SERVICE BULLETIN

No. 224

SUBJECT: Mitchell Bulletin No. A55 — Modification of Pitch Servo

SUPPLEMENT TO SERVICE BULLETIN NO. 224

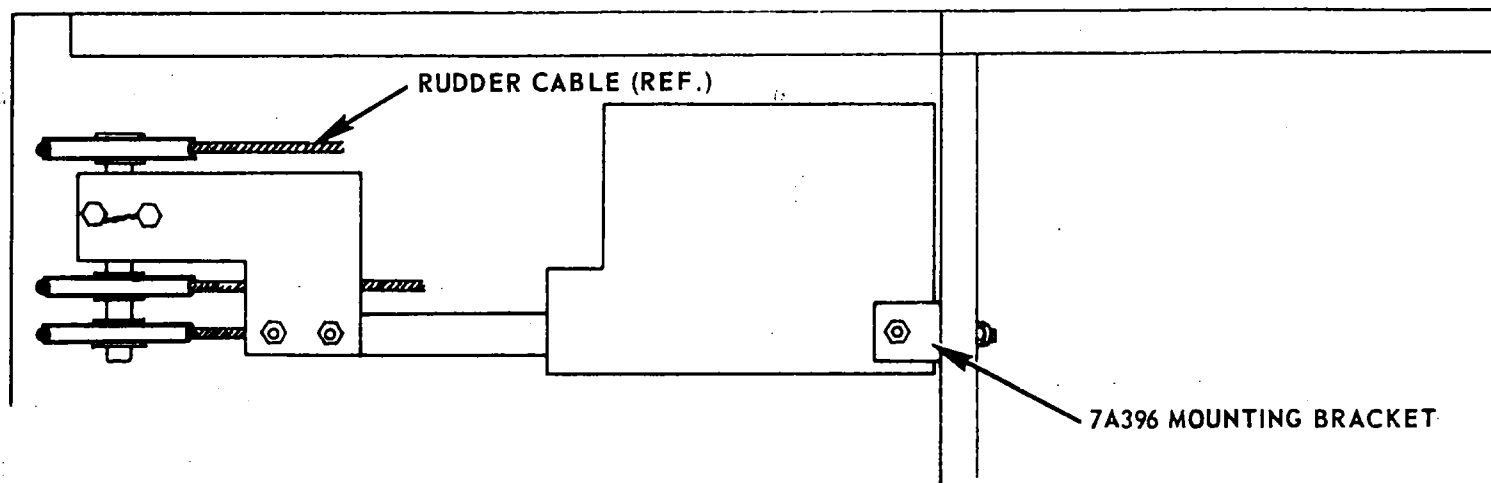
There have been several reports of interference occurring between the pitch servo rack assembly and the screw heads of the AN510-10R16 screws that attach the forward end of the servo to the forward mounting bracket. These screw heads should be inspected to be sure they are flush.

If the screws are not flush, then the pitch servo spacer block, part number 25422 should be removed and the two (2) holes increased to 1/4" diameter. Any subsequent installation should have the holes in the pitch servo block, part number 25422, drilled to 1/4" before it is installed.

Cable must have upward deflection
of 1/16" thru full travel of rack assy.

Install this bracket so the upper portion of
the fairlead contacts the top of the cable.
Use shim washers between skin and bracket
to prevent cable deflection of more than 1/8
inch from its normal position.
